Pathfinder Generating Plant
Docket No. 030-05004
Byproduct Materials License No. 22-08799-02

Subject: USNRC Request For Additional Information

Pathfinder Decommissioning Plan Replacement Pages

Appendix G – Response to NRC Requests for Additional Information

Figure 2-1
Pathfinder Site Plan

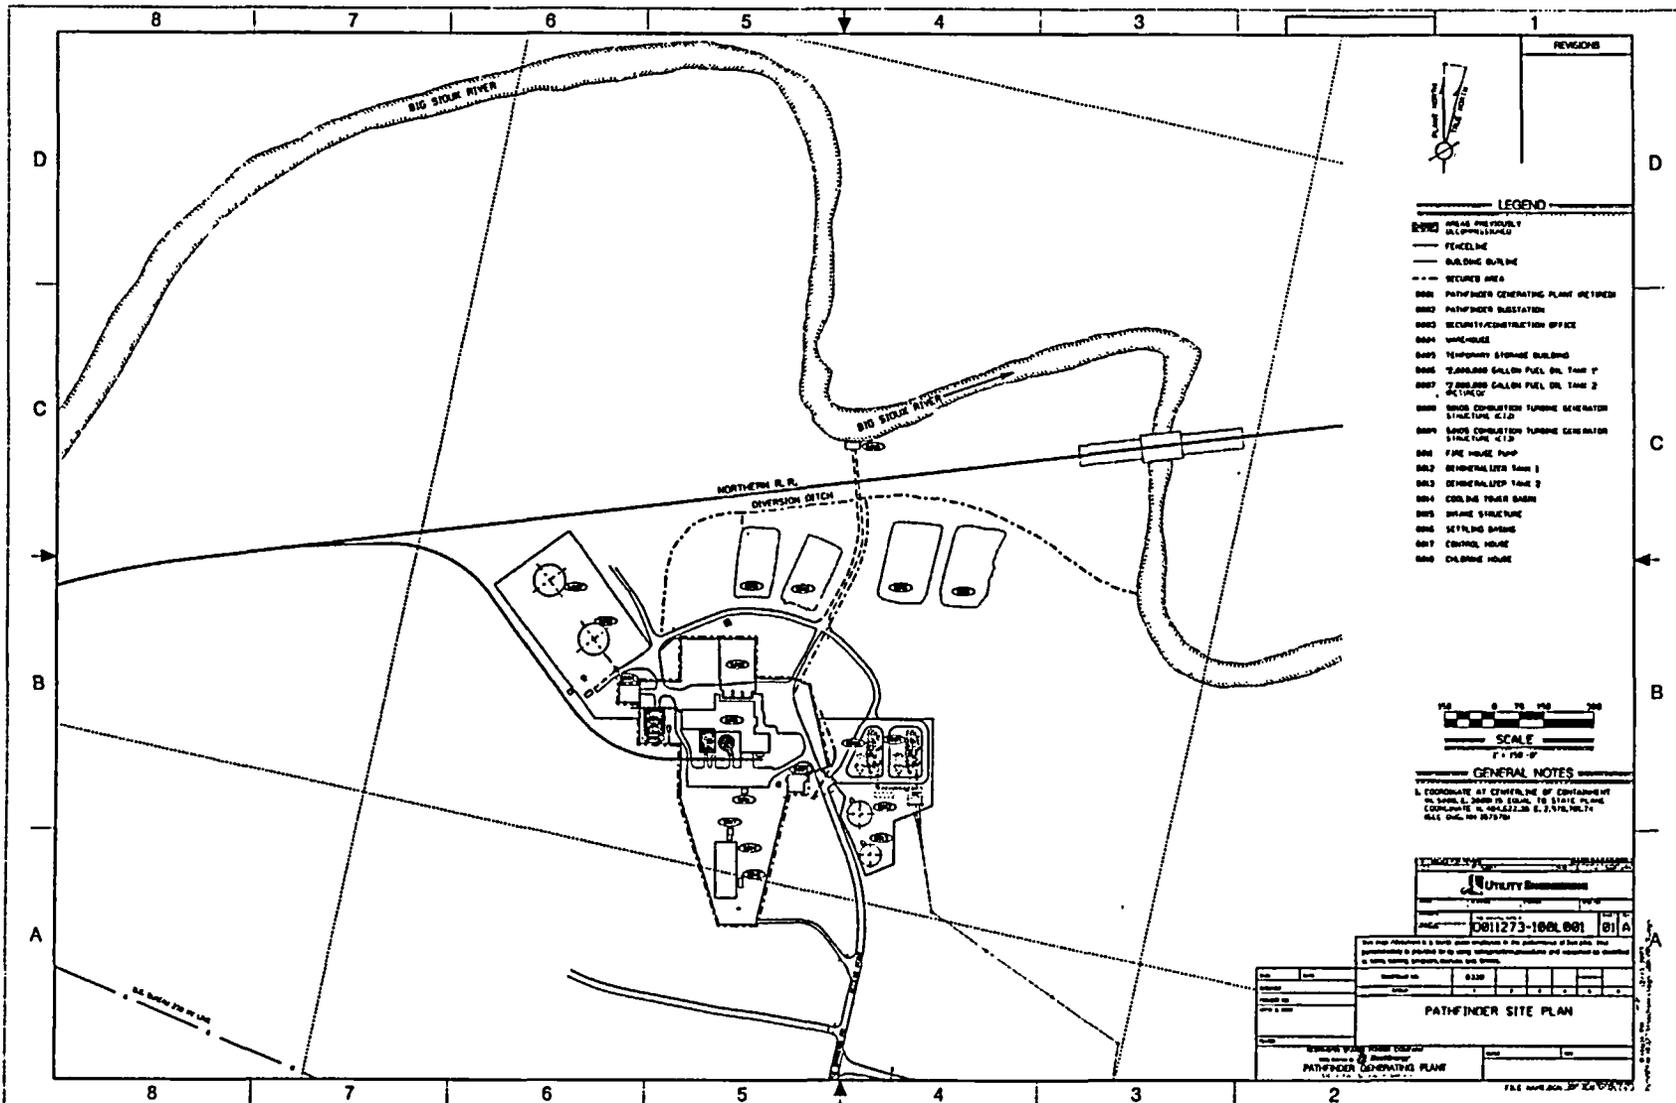
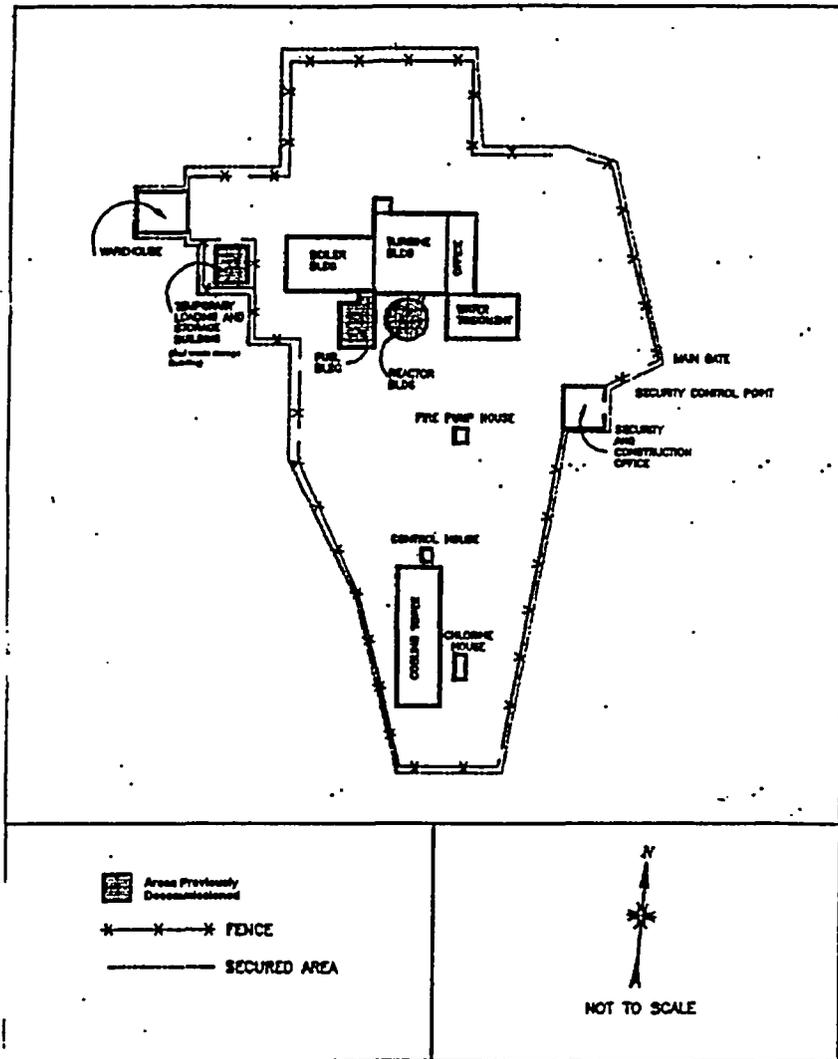
1. *Provide a statement in the Pathfinder Decommissioning Plan (DP) that provides a basis to conclude that Xcel Energy property outside the secured area has not been impacted by licensed operations. Page 2-3 of the DP states "Although Xcel Energy owns additional land that surrounds the Pathfinder location, the Pathfinder site as referred to herein, principally includes the secured area shown in Figures 2-1 and 2-2. The buildings and the areas enclosed within the secured area and the influent and effluent pathways to the Big Sioux River (e.g., settling ponds and diversion ditch) are the subjects of this decommissioning plan. Three of the existing buildings have been previously decommissioned and approved for unrestricted release."*

Figure 4-1
Organizational Chart

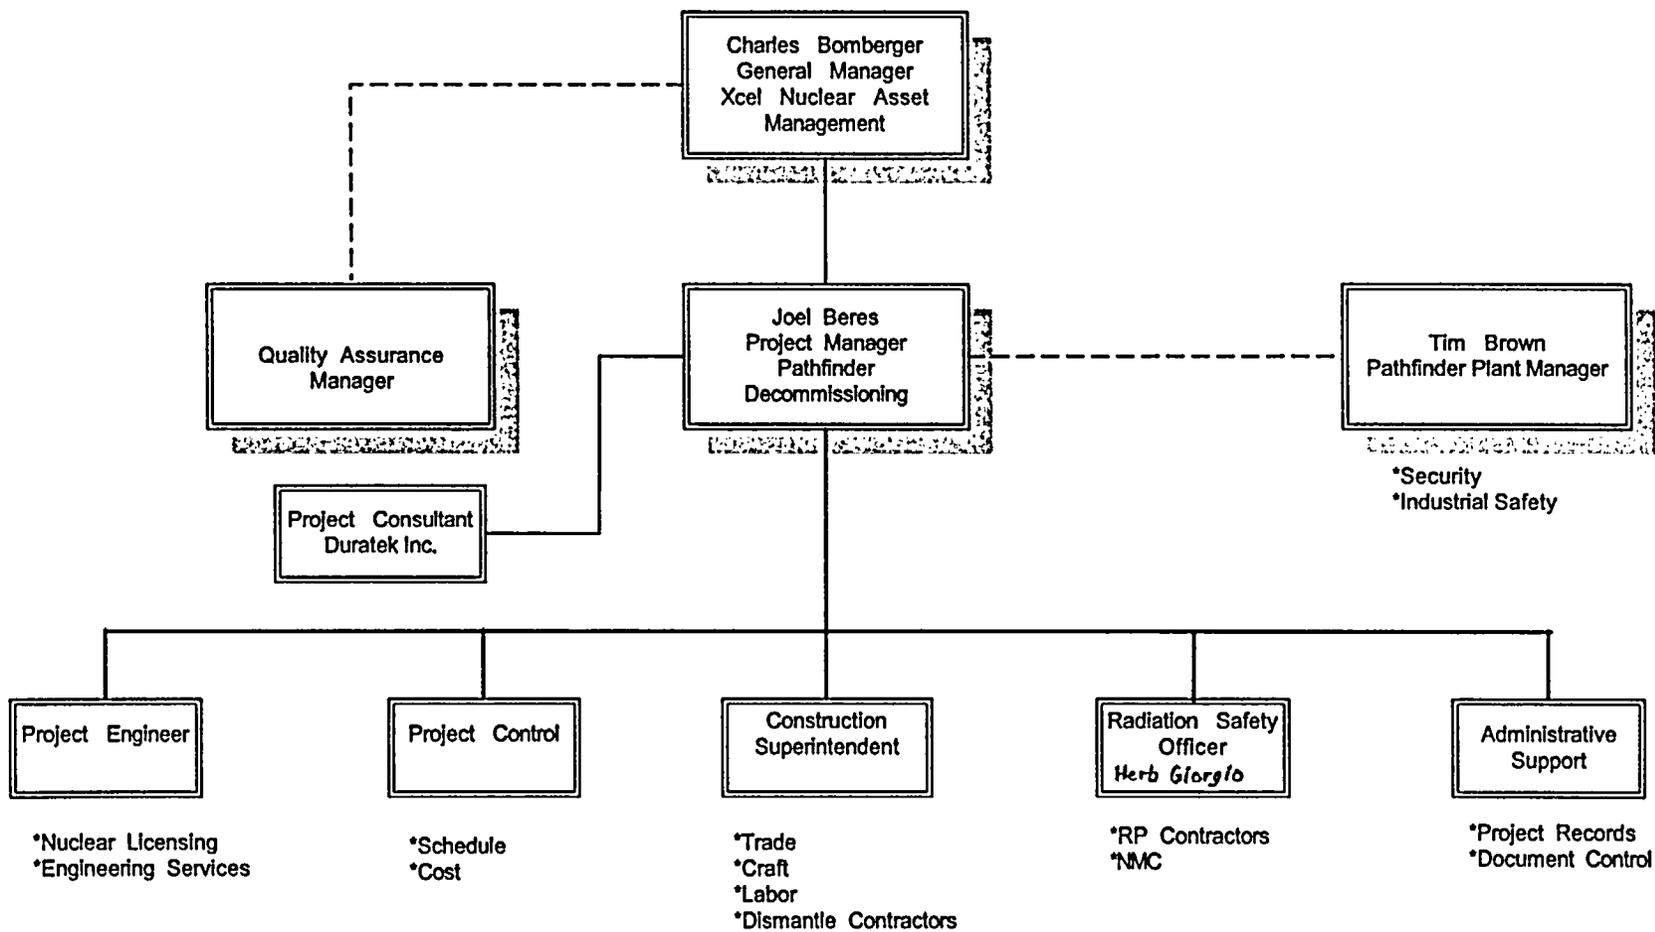
3. *Identify the names of individuals responsible for all decommissioning project units on the organization chart. The Organizational Chart (DP Page 22, Figure 4.1), includes the names of individuals responsible for some decommissioning organizational units. However, it omits the identity of persons responsible for other decommissioning project units, such as the, Quality Assurance Manager, Radiation Safety Officer, etc.*

Herb Giorgio, CHP, is the Radiation Safety Officer at Pathfinder. Figure 4-1 of the Plan (p. 22) has been updated to reflect this change.

Depending on the workload involved, some of the duties may be more efficiently performed by the Project Manager, the RSO, or by qualified contractors. Consequently, the names of the support positions will remain blank. The core team, which is already shown in Figure 4-1 and includes the RSO above, will stay the same for the duration of the project barring unforeseen circumstances such as job change, retirement, etc. Once remediation activities, which are scheduled for late 2005, begin, Xcel Energy will make reasonable efforts to keep the project team members together for the remaining duration of the decommissioning effort.
